Rezoning Application: RZ-PD 25-0932

Hillsborough
County Florida

Development Services Department

PETITION NO: RZ 25-0932

FIGURE 2: PROPOSED TYPICAL SECTION

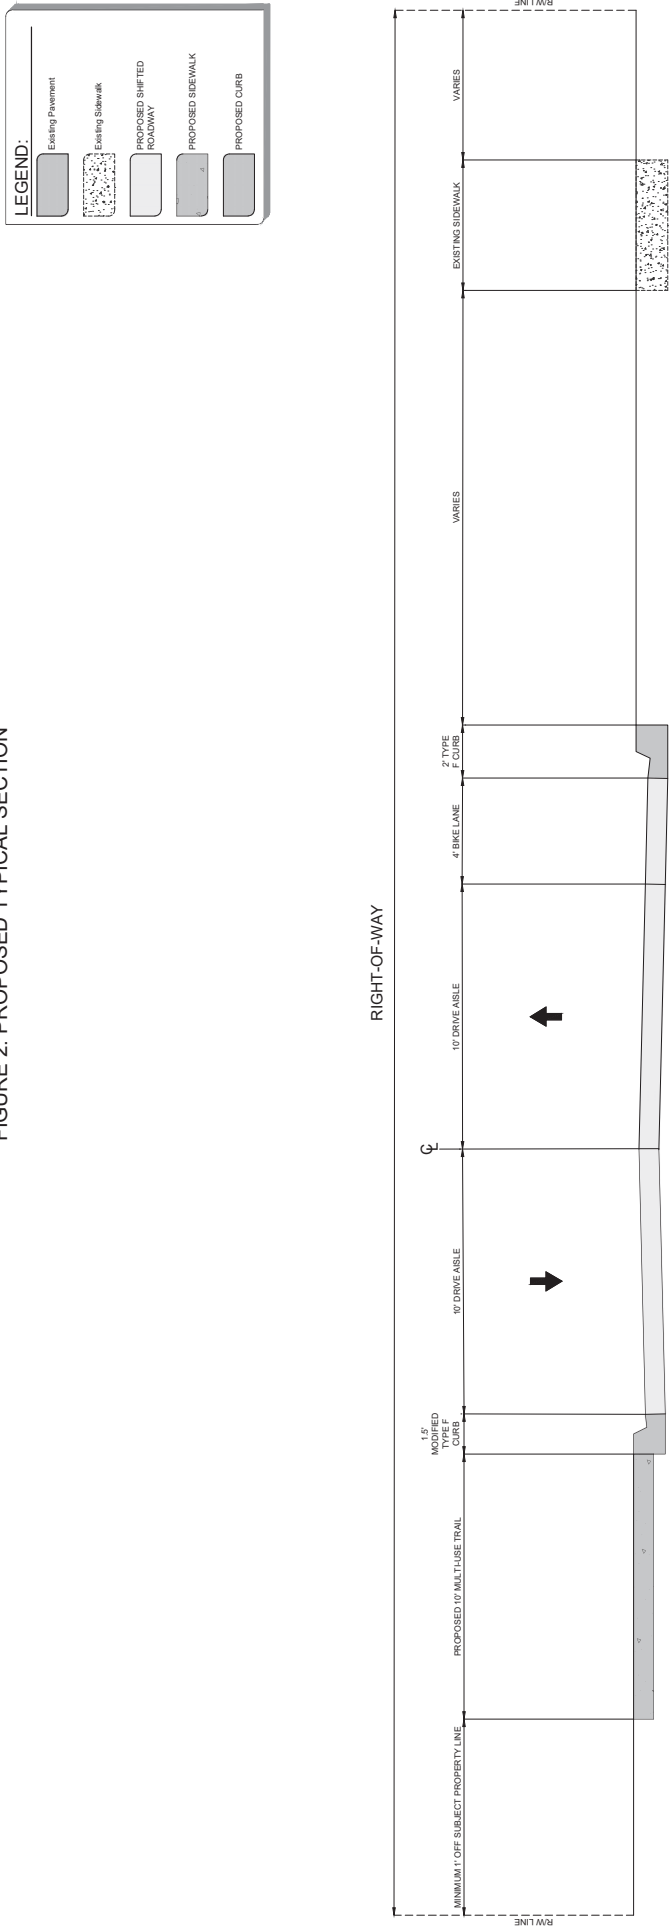
As Fern Hill Dr. is a substandard collector roadway, the applicant’s Engineer of Record (EOR) submitted a Design Exception request (dated July 29, 2025 and last revised October 13, 2025) to determine the specific improvements that would be required by the County Engineer. Based on factors presented in the Design Exception request, the County Engineer found the request approvable (on October 14, 2025). The developer will be required to make certain improvements to Fern Hill Dr. consistent with the Design Exception. The Design Exception authorizes deviations from the 2021 Transportation Technical Manual (TTM) Typical Section – 4 (TS-4) (for 2-lane, Urban Collector Roadways) standards governing such roadways. Specifically:

1. The developer shall be permitted to maintain the 10-foot-wide travel lanes in lieu of the 11-foot-wide travel lanes required by TS-4;
2. On the east side of Fern Hill Dr., the developer shall be permitted to utilize 4-foot-wide bicycle lanes in lieu of the 7-foot-wide buffered bicycle lanes required pursuant to TS-4, and is proposing to fill in an approximately 350-foot-long gap in the existing bicycle lane along the east side of the roadway;

3. On the west side of Fern Hill Dr., the developer shall be permitted to construct a 10-foot-wide multi-purpose pathway in lieu of the 5-foot-wide sidewalk and 7-foot-wide buffered bicycle lane required per TS-4, and is proposing to install the pathway along their project frontage and continuing along the west side of Fern Hill Dr. for an additional +/- 210-feet south of the southern PD boundary (to connect with the existing bicycle lane and sidewalk);

4. On the west side the developer is also proposing to eliminate the 5-foot-wide grass strip/separator between the back of the “Type F” curb and the closest edge of the multi-purpose pathway as required by TS-4, as well as reduce the 2-foot grass strip between the multi-purpose pathway and the closest edge of the right-of-way (as required by TS-4) down to 1-foot; and,

5. The developer will be required to install Type “F” curb along both sides of Fern Hill Dr. (specifically along those areas where bicycle lanes and multi-purpose paths are being constructed).

If PD 25-0932 is approved, the County Engineer will approve the Design Exception.
